SUBJECT: BRAIDWOOD STATION, UNITS 1 AND 2, AND BYRON STATION, UNIT NOS. 1 AND 2 - ISSUANCE OF AMENDMENTS RE: CLARIFICATION OF OPERATING LICENSE AND TECHNICAL SPECIFICATIONS (TAC NOS. MD9360, MD9361, MD9362, AND MD9363)

ATTACHMENT TO LICENSE AMENDMENT NOS.160 AND 160

ATTACHMENT TO LICENSE AMENDMENT NOS.165 AND 165

Figure 3.7.16-1 (page 1 of 1)
Region 2 Fuel Assembly Burnup Requirements

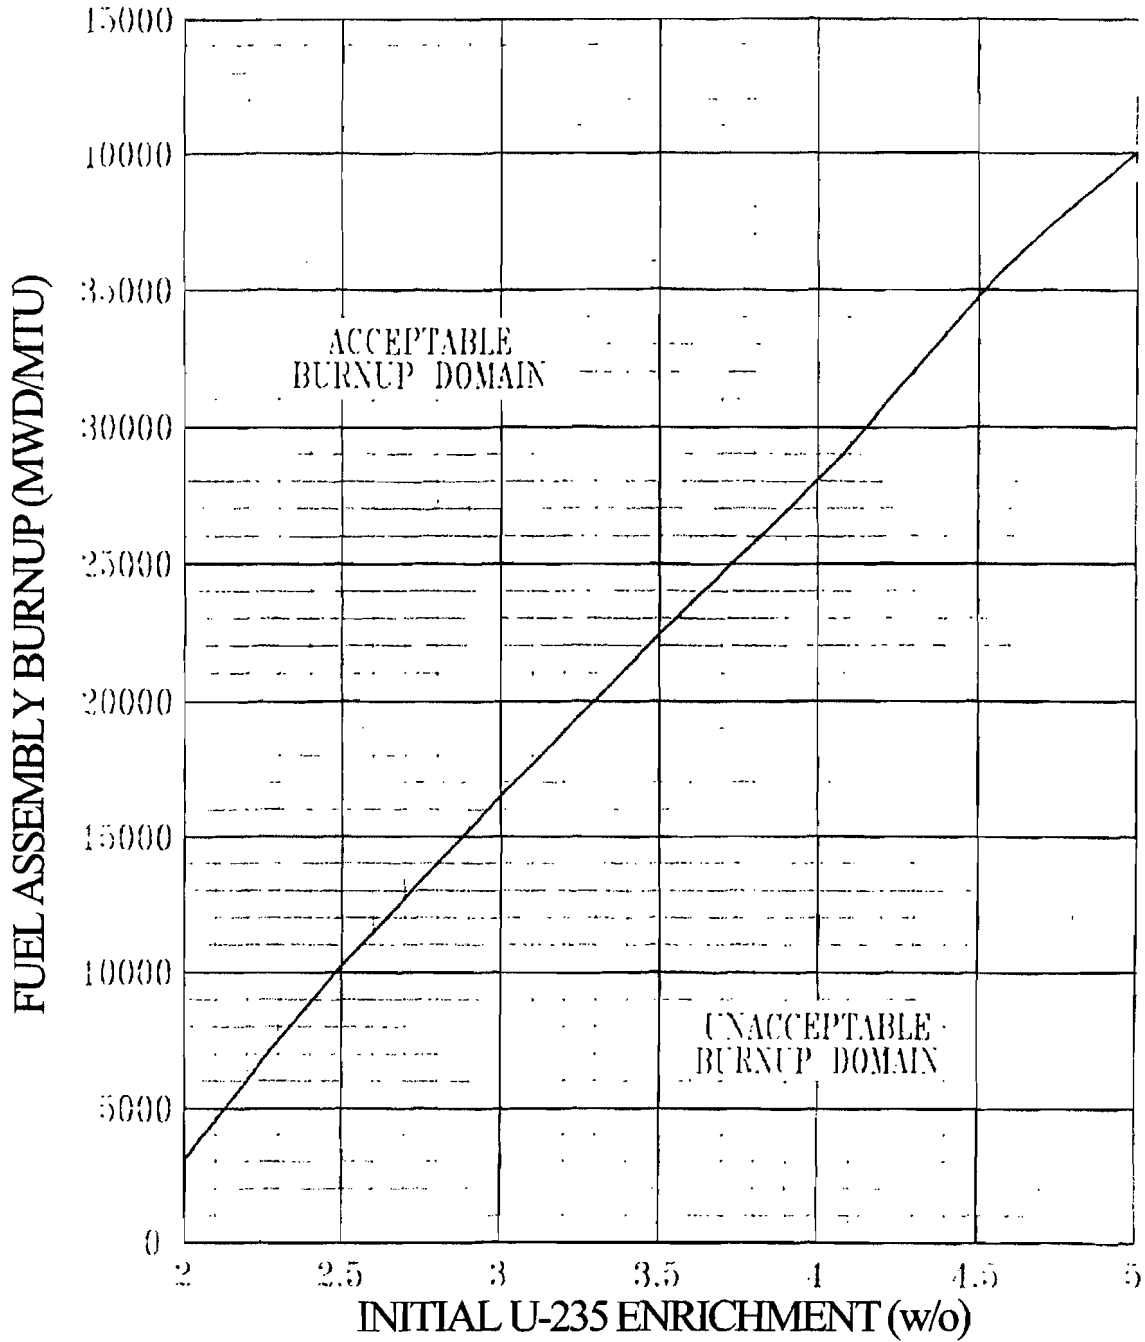
Revise TS 3.7.15, "Spent Fuel Pool Boron Concentration," TS 3.7.16, "Spent Fuel Assembly Storage," and TS 4.3.1, "Criticality," to remove all references to Joseph Oat spent fuel pool storage racks, including the deletion of existing Figures 3.7.16-1, 3.7.16-2, and 3.7.16-3, the renumbering of existing Figure 3.7.16-4 to 3.7.16-1, and required formatting changes. As stated in the LAR, the Joseph Oat spent fuel storage racks have been replaced with Holtec spent fuel storage racks as of January 1, 2001. (The licensee noted in the LAR that similar changes were not proposed for Braidwood because the Braidwood Station TS were previously revised to remove references to Joseph Oat fuel storage racks in Braidwood License Amendment No. 145 (ADAMS Accession No. ML072620362)). The NRC staff finds that, because the Joseph Oat spent fuel storage racks are no longer installed at Byron, the removal of references to these

- LCO 3.7.16 Each spent fuel assembly stored in the spent fuel pool shall, as applicable:
- a. Region 1 of spent fuel pool storage racks |
Have an initial nominal enrichment of ≤ 5.0 weight percent U-235 to permit storage in any cell location.
 - b. Region 2 of spent fuel pool storage racks |
Have a combination of initial enrichment and burnup within the Acceptable Burnup Domain of Figure 3.7.16-1. |
